ORIGINATION FORM

Proposed Revisions to a Standard Plans Index (Please provide all information — Incomplete forms will be returned)

Index Number: 700-030

Index Title: Wind and Hanger Beams for Overhead Signs

DETAIL "B"

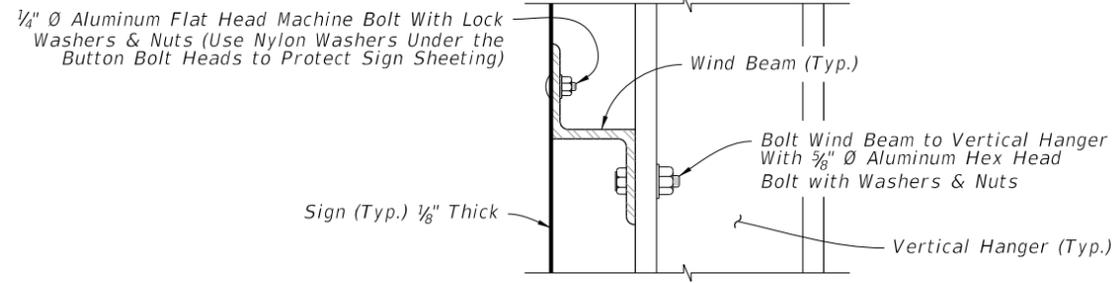
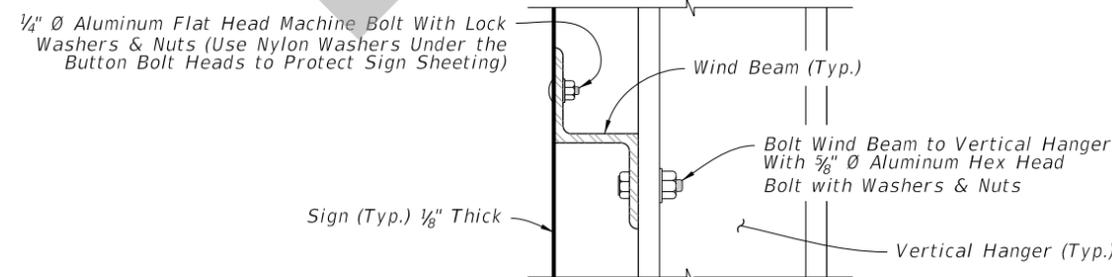
Change Note 6.A.b reference to ASTM B308 to ASTM B221 throughout Standard Plans as an administrative change.
Corrected Title block of Hanger Table.

I-beam size label was incomplete as previously shown. Should be I 6x4x4.69 and Z 5/3.25 x 4.01

HANGER TABLE (I 6 X 4 x 4.69 or Z 5 x 3 1/4 x 4.01)					
Number of Vertical Hanger Beams Based on Wind Speed and Sign Length (L)					
	2 Hangers	3 Hangers	4 Hangers	5 Hangers	6 Hangers
130 mph	L ≤ 20'	20' < L ≤ 30'	30' < L ≤ 40'	40' < L ≤ 50'	--
150 mph	L ≤ 18'	18' < L ≤ 27'	27' < L ≤ 35'	35' < L ≤ 45'	45' < L ≤ 50'
170 mph	L ≤ 15'	15' < L ≤ 20'	20' < L ≤ 28'	28' < L ≤ 35'	35' < L ≤ 43'
